Access Compliance Report

Public Rights-of-Way

(Curb Ramps)

Intersection ID: 10674	Main Street: E_W_T_HARRIS_BV	Cross Street: MARKWAY_DR	Location: NE
ADA ID: DBFADC009DCA	Ramp Type: PerpDiag	Initial Pass/Fail: Fail	Overall Compliance: No
Severity Score: 12.5			
Codes/Mitigation Info/Possible Solution		Field Measurements/Component Compliance

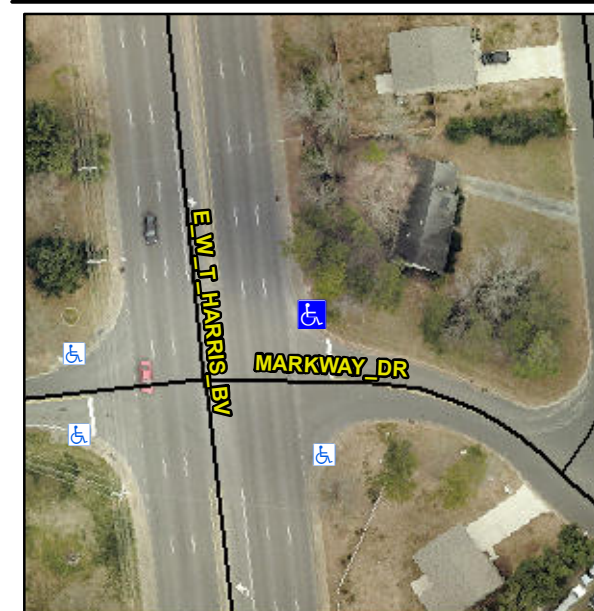
Not Found, R304.2.2

Compliance	Description	Data	Compliance	Description	Data
N/A	Ramp Length (in)	61.5	No	Ramp Slope (%)	9.8
Yes	Ramp Width (in)	48.0	Yes	Ramp XSlope (%)	0.2
N/A	Flare Type LT	N/A	N/A	Flare Type RT	N/A
N/A	Flare Slope LT (%)	N/A	N/A	Flare Slope RT (%)	N/A
N/A	Flare Traversable LT?	N/A	N/A	Flare Traversable RT?	N/A
N/A	Landing Length (in)	N/A	N/A	DWS Provided?	N/A
N/A	Landing Width (in)	N/A	N/A	DWS Contrast?	N/A
N/A	Landing Slope (%)	N/A	N/A	DWS Length (in)	N/A
N/A	Landing X Slope (%)	N/A	N/A	DWS Full Width?	N/A
N/A	Landing Curb? (Y/N)	N/A	N/A	DWS Offset (in)	N/A
N/A	Shared Landing?	N/A			
N/A	Gutter Ponding?	Yes	N/A	Gutter Slope (%)	N/A
N/A	Gutter Lip Ht (in)	N/A	N/A	Gutter X Slope (%)	N/A
N/A	Painted X Walk1?	No	N/A	Painted X Walk2?	No
	X Walk 1 Direction	To W		X Walk 2 Direction	To S
N/A	X Walk 1 Width (in)	N/A	N/A	X Walk 2 Width (in)	N/A
	X Walk 1 Slope (%)	2.2		X Walk 2 Slope (%)	1.7
	X Walk 1 X Slope (%)	0.8		X Walk 2 X Slope (%)	0.0

Remove & Replace Curb Ramp With Two New Directional Ramps or Equivalent.
